LOS GATOS PLANNING COMMISSION 2/8/2006
Item #4, 54 Chester Street

REPORT TO: The Planning Commission
FROM: The Development Review Committee
LOCATION: 54 Chester Street
Architecture and Site Application S-05-031

Requesting approval to demolish a pre-1941 residence, construct a new single family residence and accessory structure with reduced setbacks and request for an interpretation of the cellar policy on property zoned R-1D. APN: 529-08-008
PROPERTY OWNER: Anna Huynh and Kevin Crane

MAIN LEVEL PLAN
 1/4" = 1'-0"

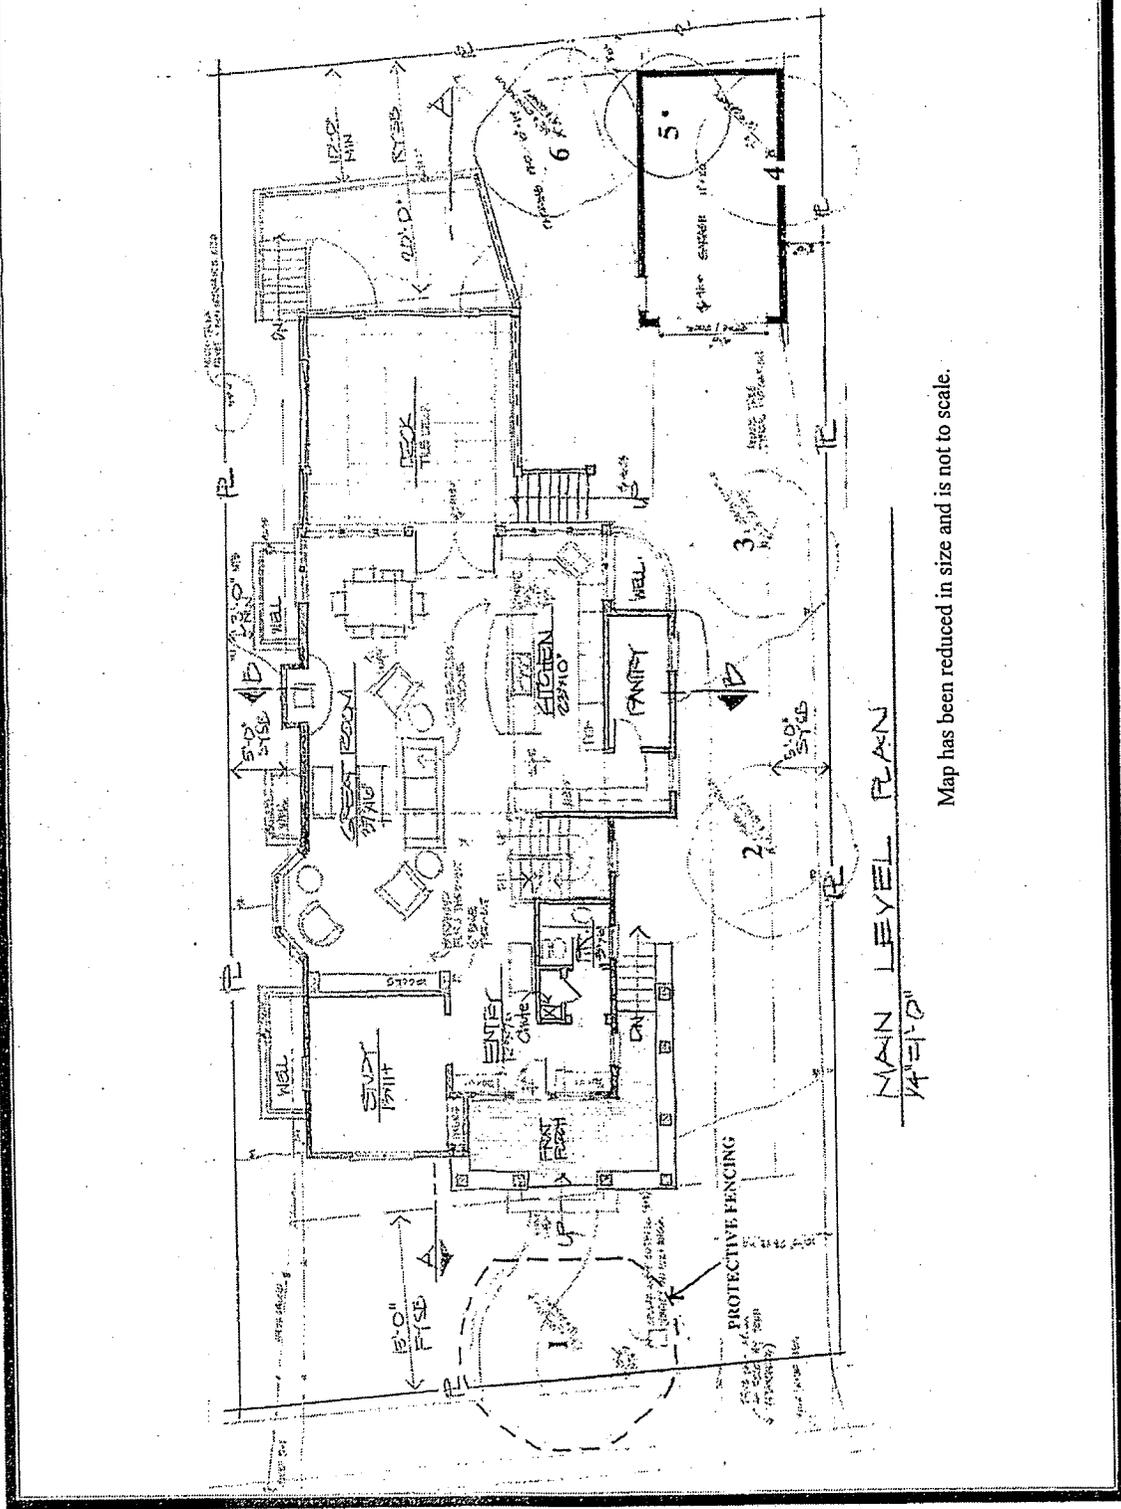
The plan reviewed for this report includes Sheet A-2 (Main Level Plan) by E. Gary Schloh Architect, dated August 11/16/05. The trees' numbers, locations and canopy dimensions are presented on an attached copy.

Tree #5 was not shown on plans reviewed. Its location has been added to the attached map and should not be construed as being surveyed.

Regarding tree #1 (a 6.5-inch Magnolia), I find it can be adequately protected provided the recommendations presented in the next section are carefully followed and incorporated into the construction plans.

3. Reference to this report should be specified on the Site Plan.
4. Any unused, existing underground utilities, lines or pipes beneath tree #1's canopy should be abandoned and cut off at existing soil grade.

5. Mitigation for the loss of trees #2 thru 6 should include the installation of three trees of 36-inch box size. The trees must be planted prior to final inspection and, as necessary for support, be double-staked with rubber tree ties. All forms of irrigation must be of a drip or soaker hose system placed on the soil surface and not in a sleeve. They should be selected from the Town of Los Gatos list of recommended trees (available by contacting the Planning Division).

6. Irrigation should not be sprayed or plant material installed within three to four feet of tree #1's trunk.
7. Trenching for irrigation and lighting beneath tree #1's canopy should be in a radial direction and established no closer than five feet from its trunk.
